**UNIFORM STANDARD DRAWINGS
CLARK COUNTY AREA**

VOLUME II - YEAR 2003 REVISIONS

Revised February 2004

SPECIFICATION REFERENCE		UNIFORM STANDARD DRAWINGS CLARK COUNTY AREA	
		"P30" PULLBOX (FOR USE IN INTERCONNECT AND COMMUNICATIONS INSTALLATIONS)	
		DATE 3-13-03	DWG. NO. 404.132
		SHEET 1 OF 1

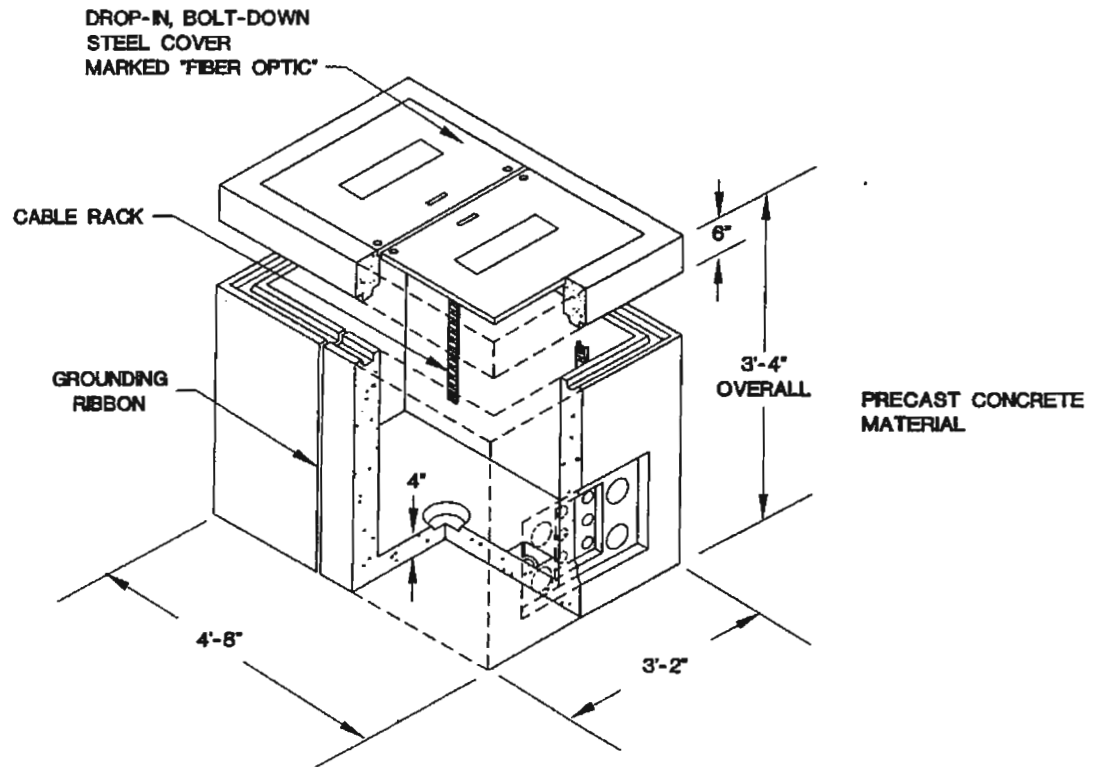
<u>DRAWING NUMBER AND TITLE</u>	<u>SHEET NUMBER(S)</u>	<u>NATURE OF CHANGE</u>	<u>EFFECTIVE DATE</u>
404.132 "P30" Pull box	1	New Drawing. Pull box drawing added for communications infrastructure.	6/1/03

SPECIFICATION REFERENCE	UNIFORM STANDARD DRAWINGS CLARK COUNTY AREA		
	"TYPE 200" PULLBOX		
	(FOR USE AT FIBER OPTIC SPLICE POINTS)		
	DATE 3-13-03	DWG. NO. 404.133	SHEET 1 OF 1

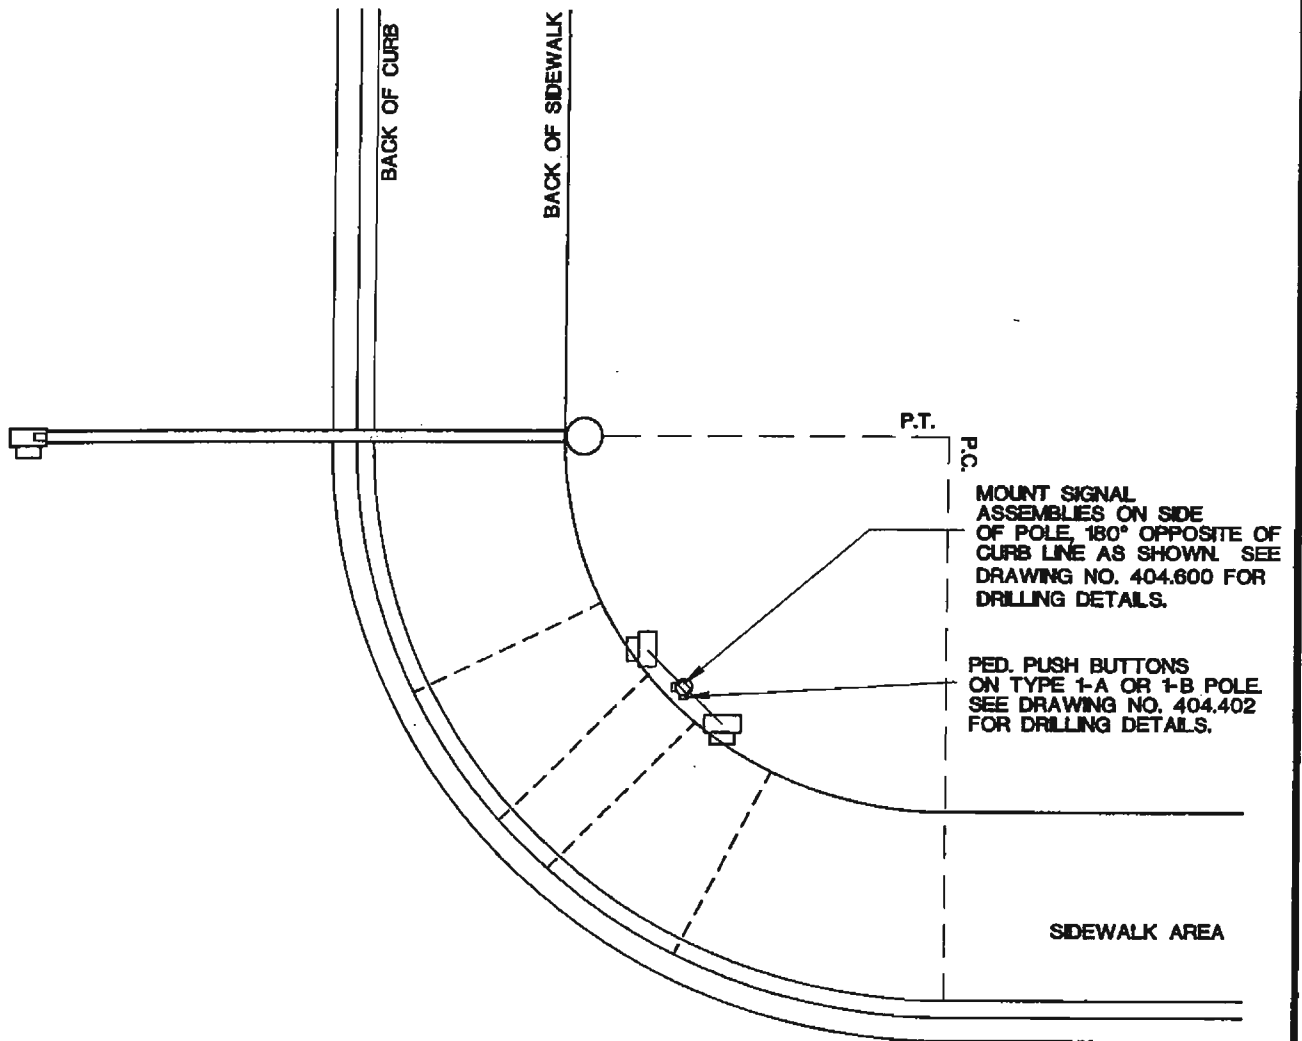
404.133 "P200" Pull box	1	New Drawing. Pull box drawing added for communications infrastructure.	"
404.1306 Typical Traffic Signal Underground Layout with Interim Street Lighting and Service Pedestal (Center of Curve Radius)	1	Revisions to accommodate communications infrastructure.	"

SPECIFICATION REFERENCE		UNIFORM STANDARD DRAWINGS CLARK COUNTY AREA		
		POLE LOCATION & SIGNAL MOUNTING AT INTERSECTION (TWO POLE) CURBSIDE SIDEWALK		
		DATE 7-10-03	DWG. NO. 404.1300	SHEET 1 OF 2

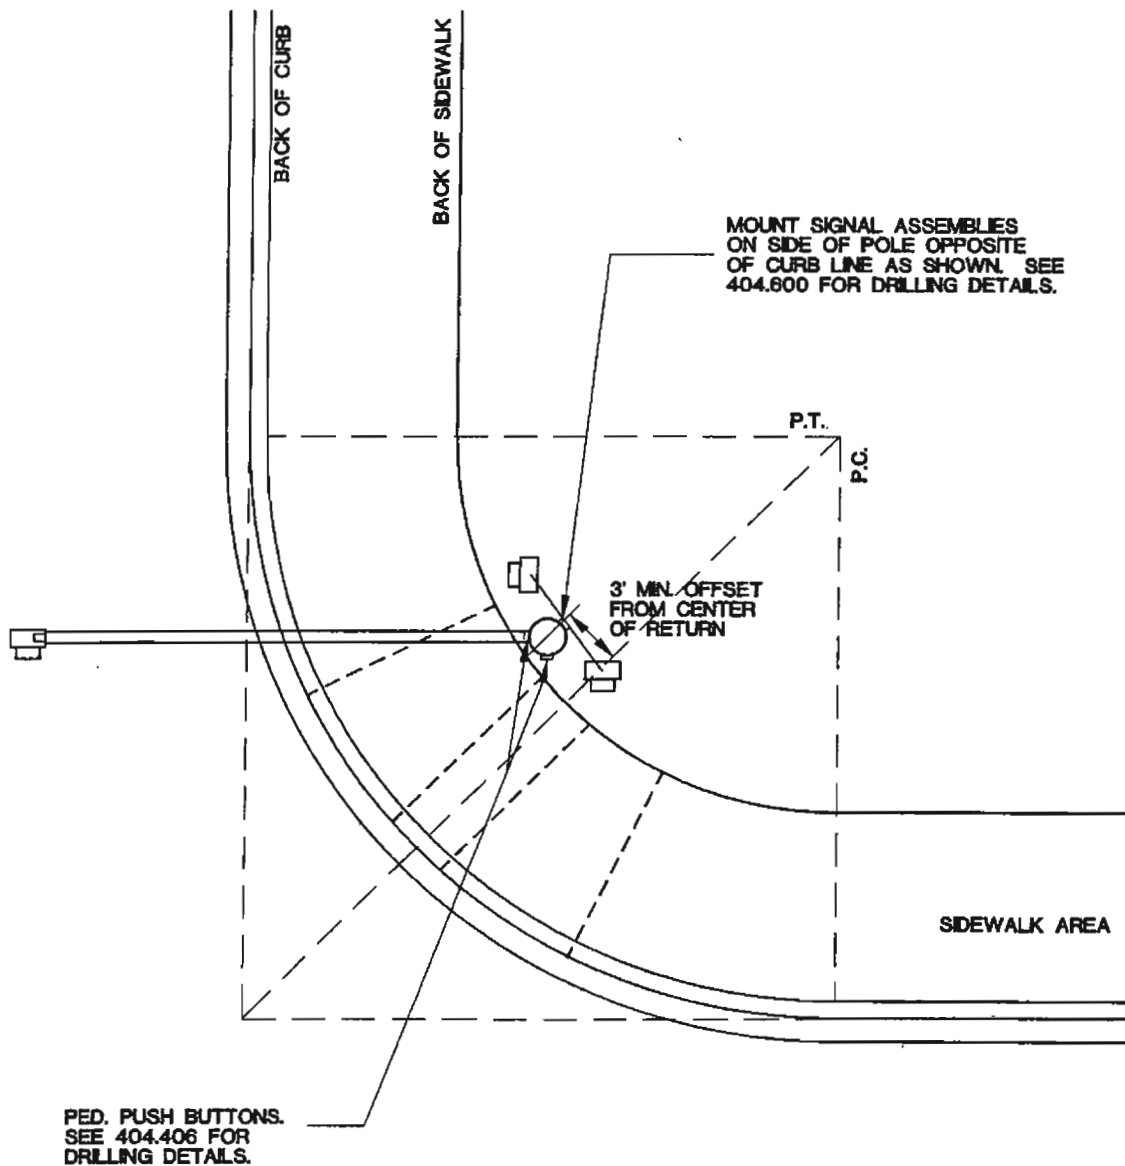
404.1300 Pole Location and Signal Mounting at Intersection (Two Pole) Curbside Sidewalk	1	Revisions to existing drawings to incorporate pedestrian and bicycle improvements resulting from the Alternative Modes Needs Assessment for the Las Vegas Valley.	8/1/03

SPECIFICATION REFERENCE		UNIFORM STANDARD DRAWINGS CLARK COUNTY AREA		
		POLE LOCATION & SIGNAL MOUNTING AT INTERSECTION (SINGLE POLE) CURBSIDE SIDEWALK		
		DATE 7-10-03	DWG. NO. 404.1300	SHEET 2 OF 2

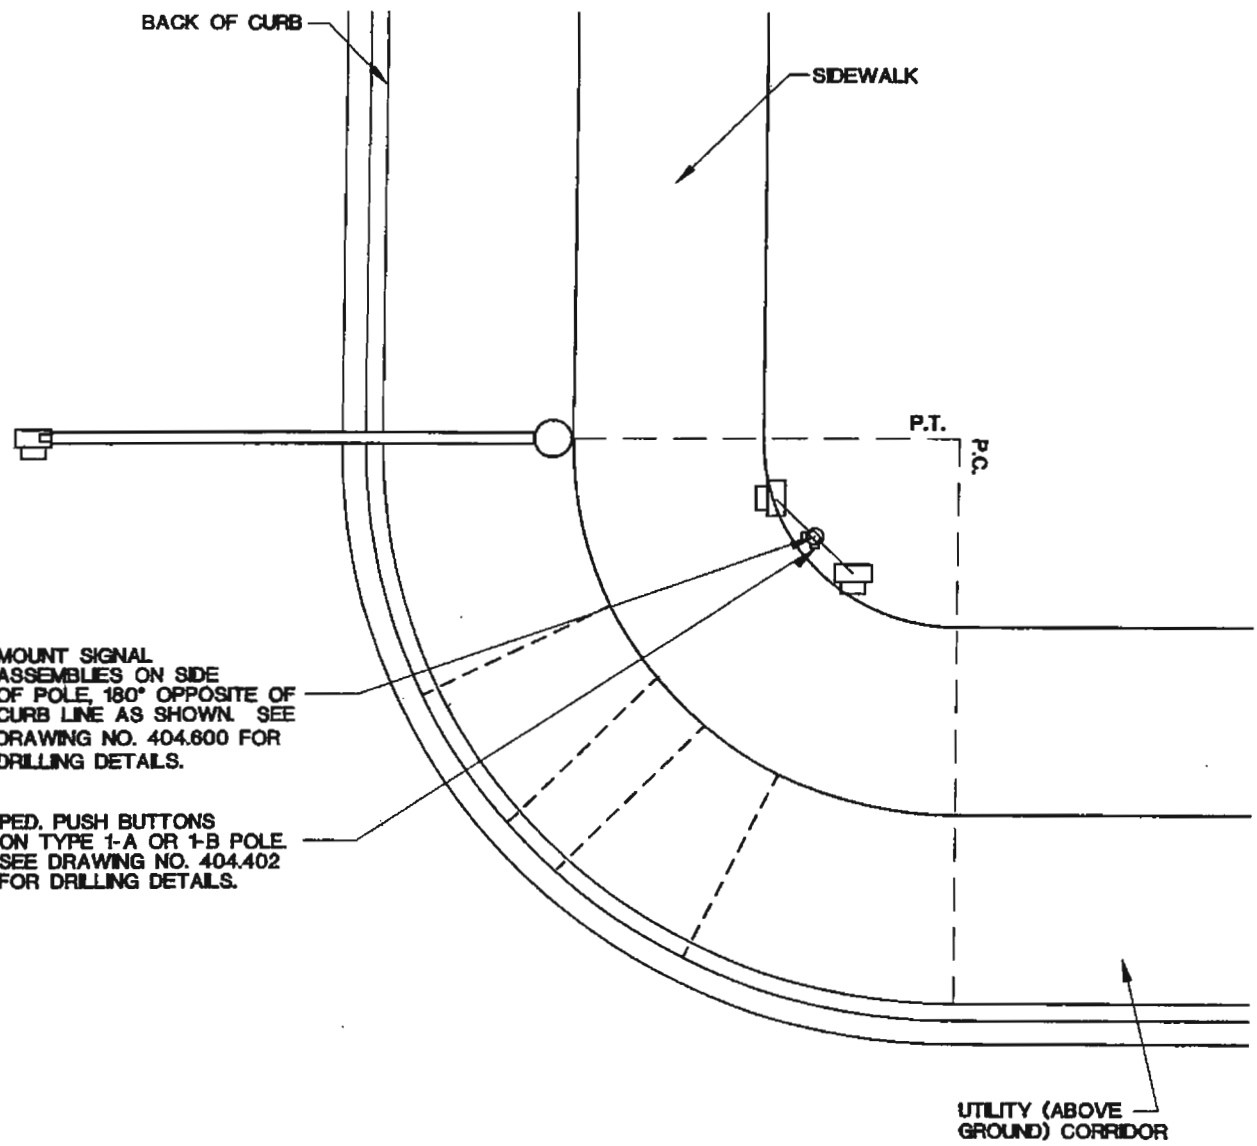
404.1300 Pole Location and Signal Mounting at Intersection (Single Pole) Curbside Sidewalk	2	"	"

SPECIFICATION REFERENCE	UNIFORM STANDARD DRAWINGS CLARK COUNTY AREA
	POLE LOCATION & SIGNAL MOUNTING AT INTERSECTION (TWO POLE) OFFSET SIDEWALK
	DATE 7-10-03 DWG. NO. 404.1300 ALT SHEET 1 OF 2

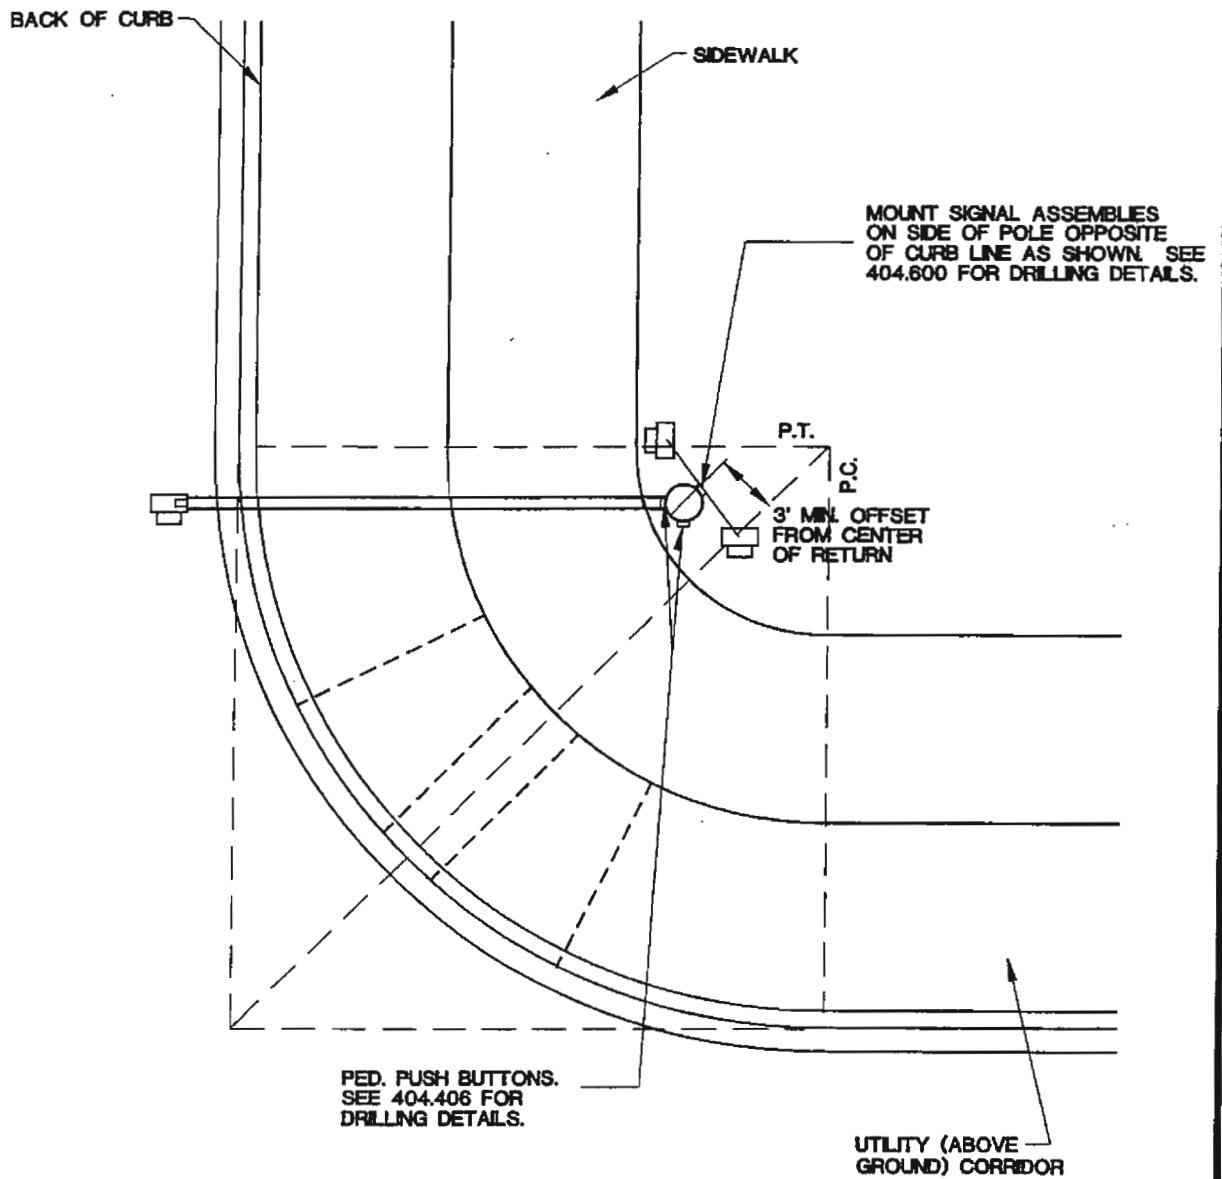
<u>DRAWING NUMBER AND TITLE</u>	<u>SHEET NUMBER(S)</u>	<u>NATURE OF CHANGE</u>	<u>EFFECTIVE DATE</u>
404.1300ALT Pole Location and Signal Mounting at Intersection (Two Pole) Offset Sidewalk	1	New drawings to incorporate pedestrian and bicycle improvements resulting from the Alternative Modes Needs Assessment for the Las Vegas Valley.	8/1/03
404.1300ALT Pole Location and Signal Mounting at Intersection (Single Pole) Offset Sidewalk	2	“	“
